# cROP Significance Determination Process 6-16-10

## DRAFT

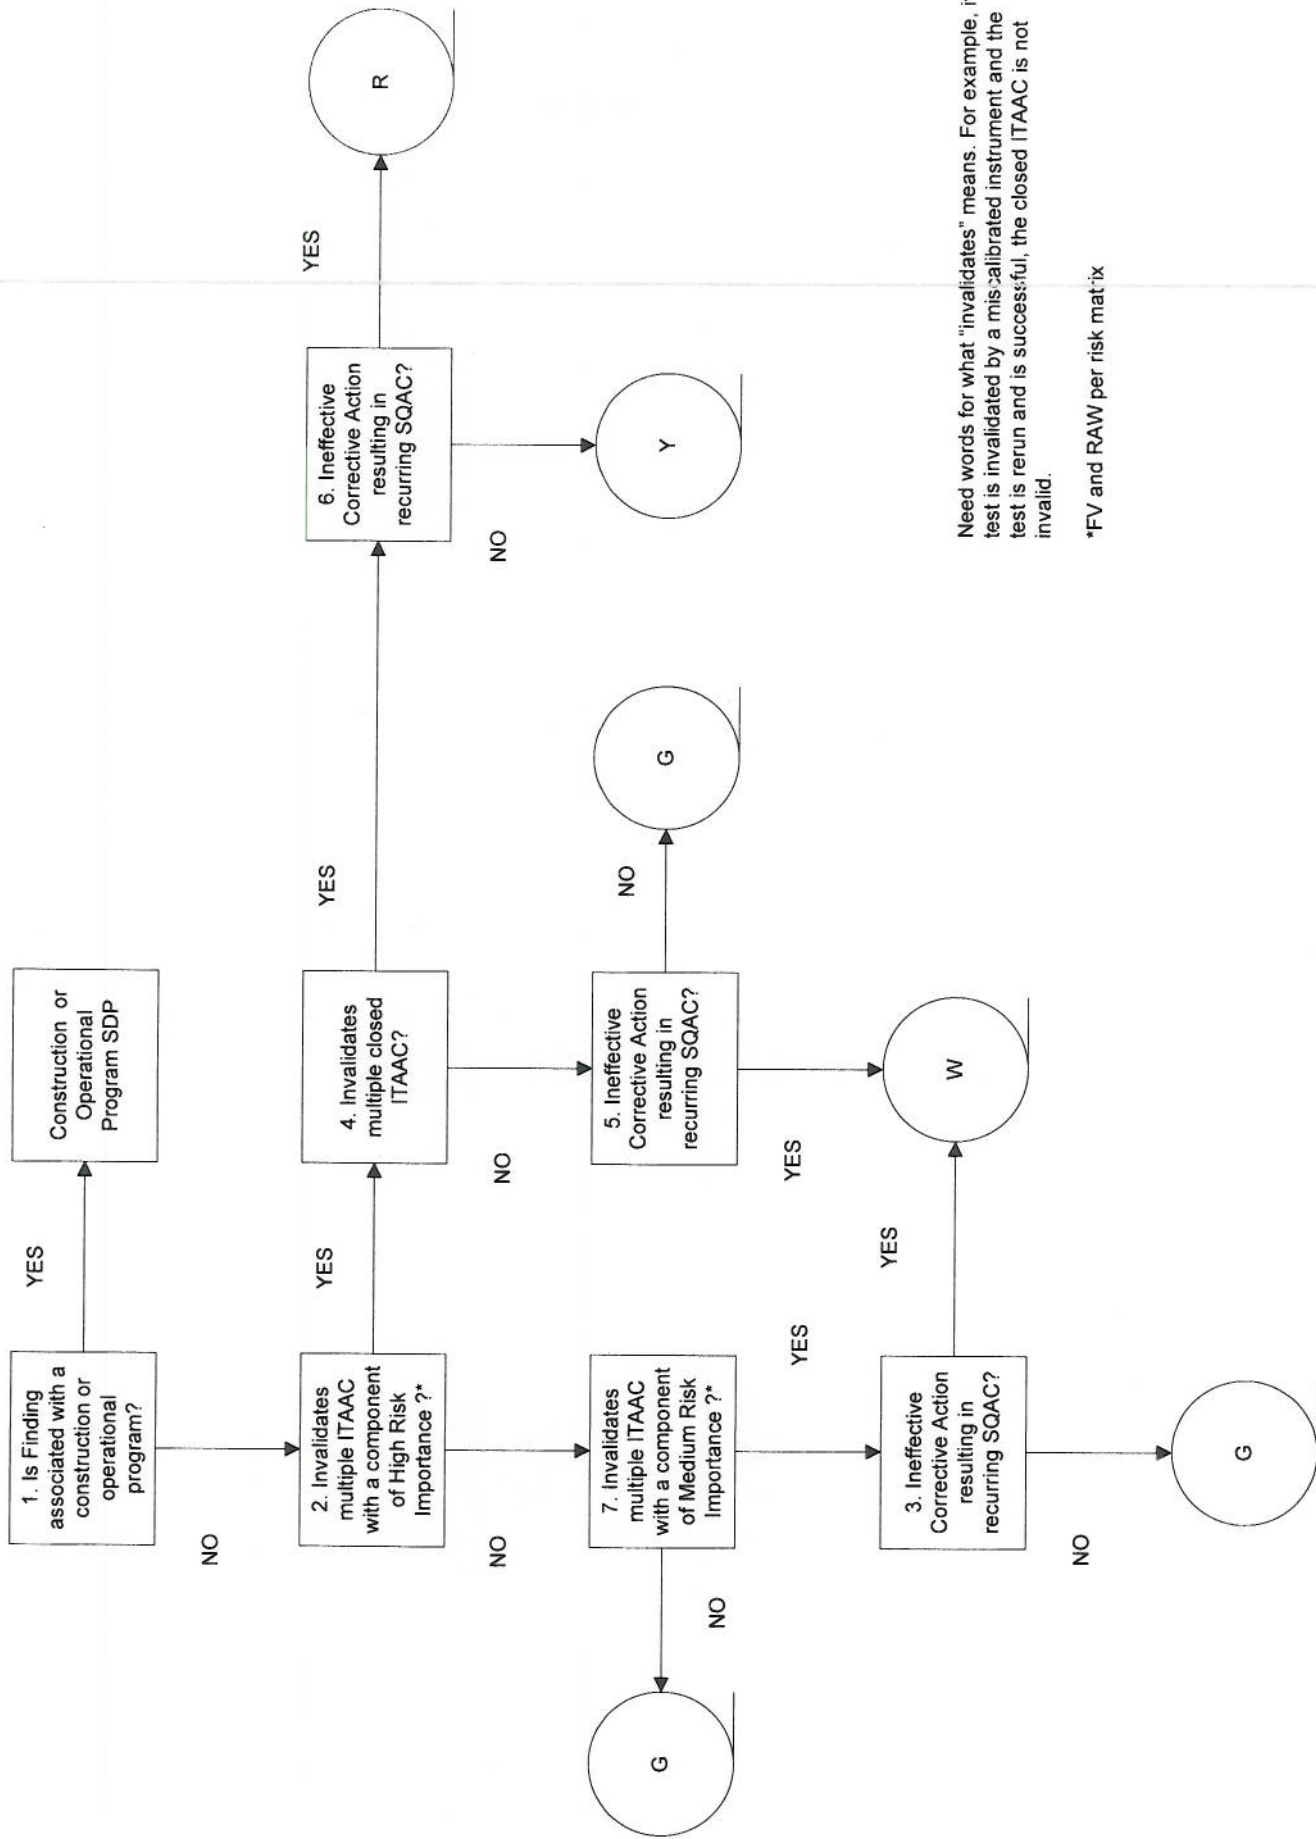
Need words for what "invalidates" means. For example, if a test is invalidated by a mis-calibrated instrument and the test is rerun and is successful, the closed ITAAC is not invalid.
